June 11, 2018

Subject: **2nd Supplemental Cannell Meadow Bypass Trail Scoping Comments for Sequoia ForestKeeper & Kern-Kaweah Chapter of the Sierra Club**

Figure 2. Well-defined roadbed – Northern Section

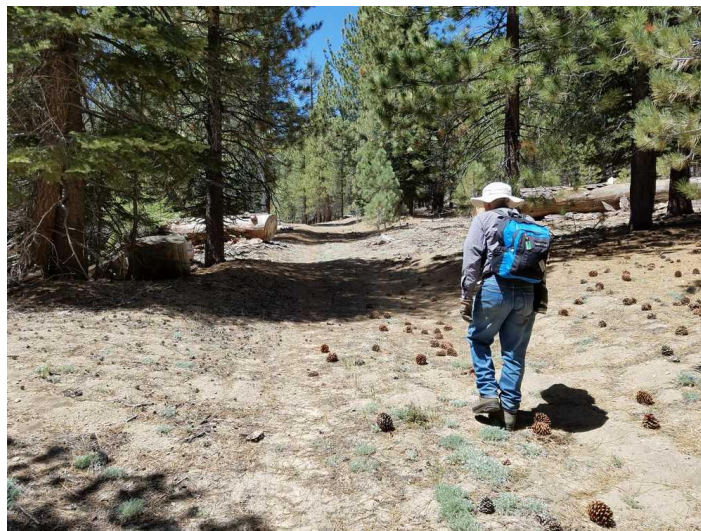
SFK followed the orange flagging along the entire trail route west of Long Meadow, which indicates its proposed location. The current proposed trail location would use steep terrain roughly 300-500 feet upslope from the edge of the meadow. It is perplexing why this steep hillside location is proposed when the area includes a well-defined old roadbed lower down the slope, which would make a more suitable trail route for OHVs. See Map Exhibit 1 (attached) and Figures 2 and 3 below.
